# Geotechnical Exploration, Inc.

**Job No. 21-13556**

Subject: **Addendum to the Report of Preliminary Geotechnical Investigation and Geologic Fault Investigation and Response to the City of San Diego Geotechnical Review**  
Proposed Javaheri Residence  
2072 Via Casa Alta  
La Jolla, California

**Seismic block analysis** of the slope with the apparent dips of 16° and 18° shown in this analysis. The values assigned for the bedding material are based on our professional geotechnical and geologic opinion of similar material.

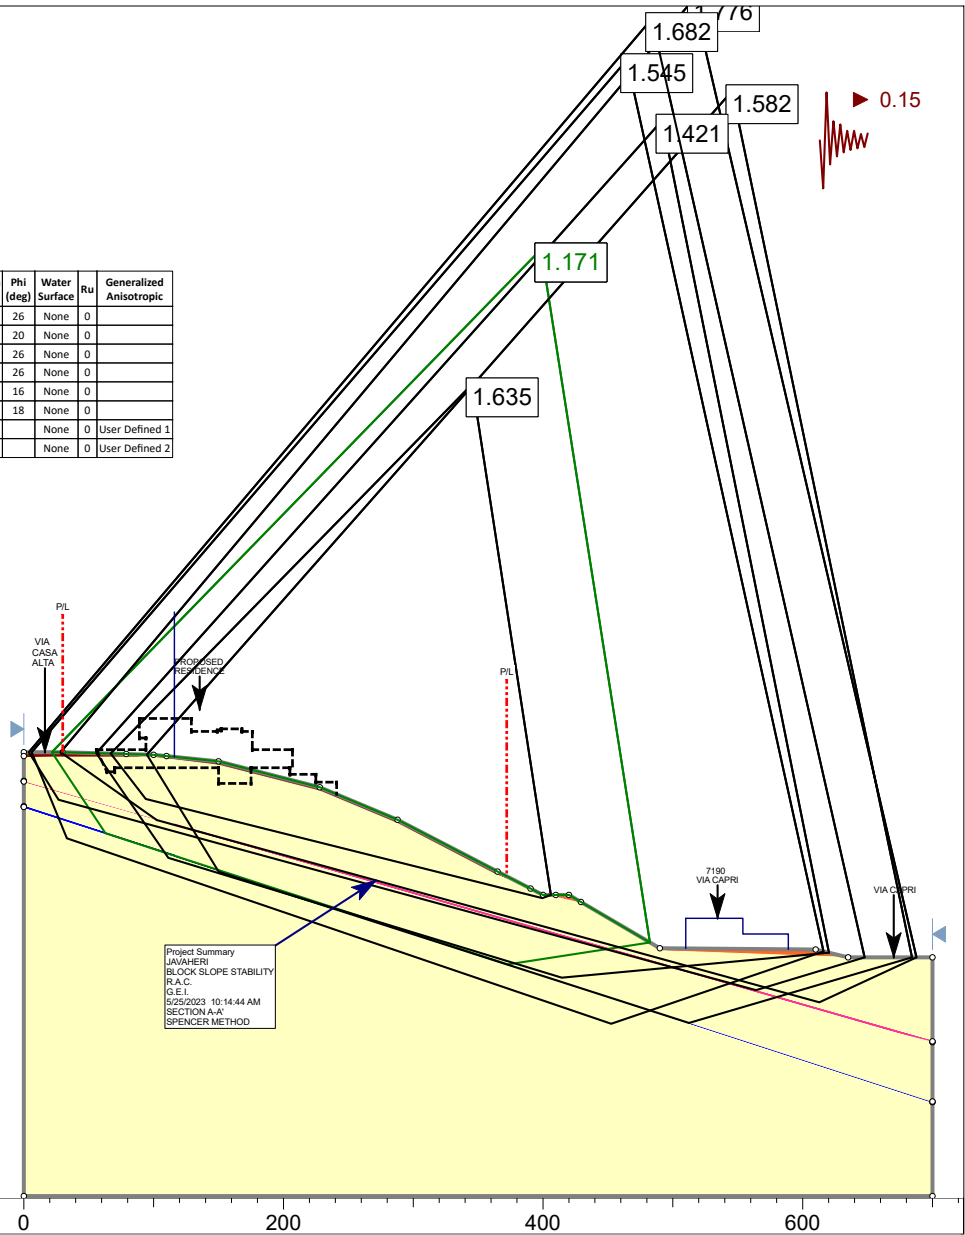
***Issue No. 9:*** *Demonstrate the site will have a factor of safety of 1.5 or greater with respect to gross and surficial slope stability following completion of the project. Provide slope stability analyses consistent with the geologic cross sections. (From Cycle 2)*

**Issue No. 24:** *The project's geotechnical consultant should clarify if their stability analysis presented in the submitted report included site-specific bedding and geologic structure data. As per the City's Guidelines for Geotechnical Reports, describe the stability analysis and discuss the results. The description should include the method of analysis, specified material profile, and specified search areas for critical failure paths. Where multiple slope stability analyses are conducted, a tabulated summary of the analyses and results should be provided. (New Issue)*

**Response:** The slope stability analysis, presented here as Appendix A, includes site-specific bedding and geologic structure data as well as the method of analysis, specified material profile, and specified search areas for critical failure paths. A tabulated summary of the analyses and results is also provided in Appendix A.

The static gross and surficial slope stability factors of safety were calculated and yielded a factor of safety value above 1.5 and greater. In the block analysis, values were assigned to bedding material for the 16- and 18-degree apparent dips as shown:

Once the static gross stability was determined, a seismic analysis was performed for the same analyzed sections. The seismic analysis yielded a factor of safety value above 1.15 as required by the City of San Diego and the State of California.
